City of Surrey  
**PLANNING & DEVELOPMENT REPORT**

File: 7913-0141-00

Planning Report Date: June 23, 2014

**LOCATION:** 17030 - Friesian Drive

**PRELIMINARY LOT LAYOUT**  
 SUBDIVISION AT 17030 FRIESIAN DRIVE, SURREY, BC

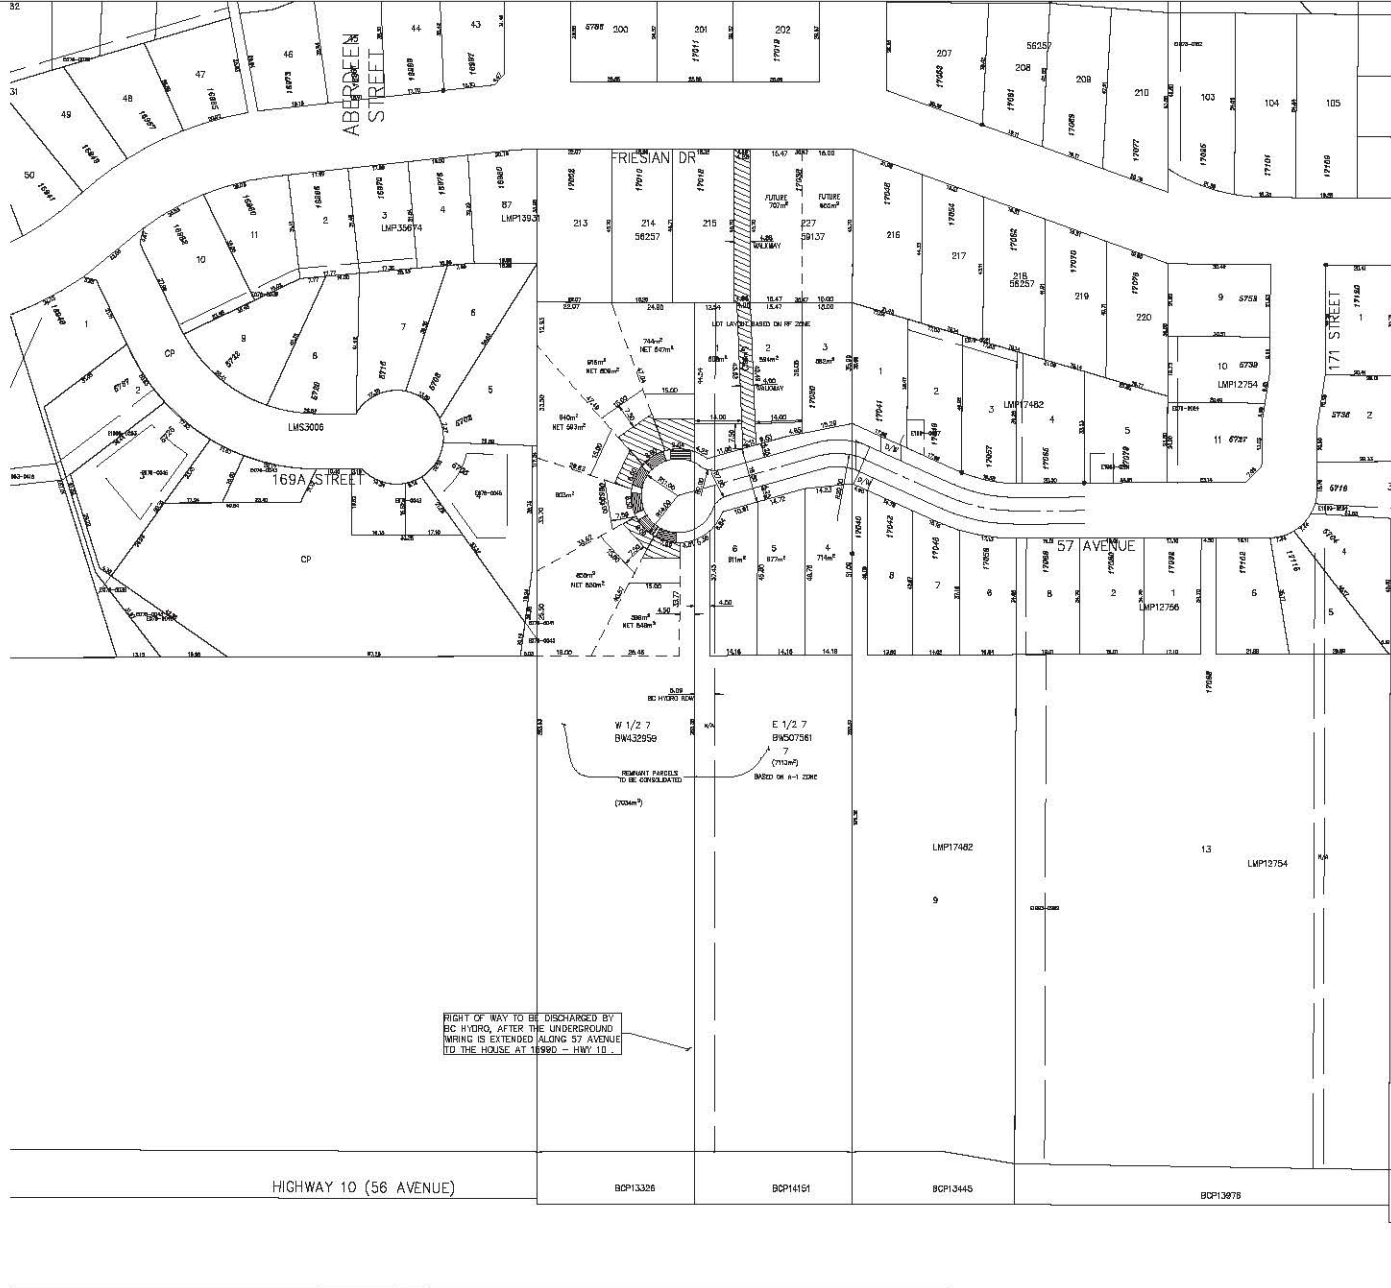
- To reduce the minimum lot width of the RF Zone from 15 metres (50 ft.) to 14 metres (46 ft.) for proposed Lots 1, 2, 4, 5 and 6.

- In order to accommodate the proposed walkway connecting Friesian Drive and 57 Avenue, a relaxation to the lot widths of proposed Lots 1 and 2 is requested.
- In order to provide a driveway access for proposed Lot 7, a 4.5-metre (15 ft.) wide panhandle is required, since an alternative driveway access cannot be secured at this time. As a result, a relaxation to the lot widths of proposed Lots 4 to 6 is requested.

- Staff worked with the applicant to revise their subdivision plan in order to accommodate the proposed walkway, and to maximize the applicant's lot yield.
- Although the proposed 14.0-metre (46 ft.) lot widths for proposed Lots 1, 2, 4 to 6 are slightly narrower, the proposed lot depths and areas exceed the minimum lot depth and lot area requirements of the RF Zone, and are consistent with the existing lot sizes located to the east along 57 Avenue.
